Summary of Items Discussed in 5/2015 APSEC Discussion Forum on 13 November 2015

FRR Enclosure to AC System inside Protected Area

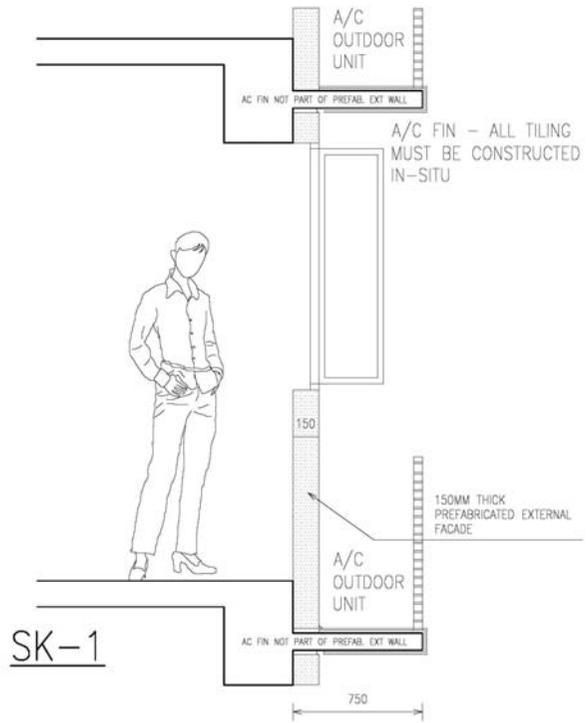
Please clarify if FRR enclosure as per Clause C9.3 of FS code 2011 is not required provided the AC system comply the requirements stipulated in the FSD circular letter (No. 4/96) dated 22 Oct 1996(para 5.2).

It was noted that FSD allowed self-contained fan coil units serving only the protected areas to be installed subject to conditions in para. 5.2.3(a), (b) and (c). BD considered that it would be difficult for electrical appliances with motors to meet relevant non-combustible standards, members should supply information on the availability of non-combustible fan-coil meeting BS:476 Part 4 or equivalent new BSEN standards with HOKLAS test certificates for BD's consideration to see if there was a need for the revision of the relevant clause in the FS Code.

Alternatively, members could consider:-

- i) installing the fan-coil units in another adequately FRR protected room not opening off directly to the required staircase at G/F level and providing ventilation to the lobby area via ventilation ducts protected with dampers in accordance with Clause C8.2 of the FS Code 2011 or
- ii) designing the required staircases not to discharge via the G/F lobby area.
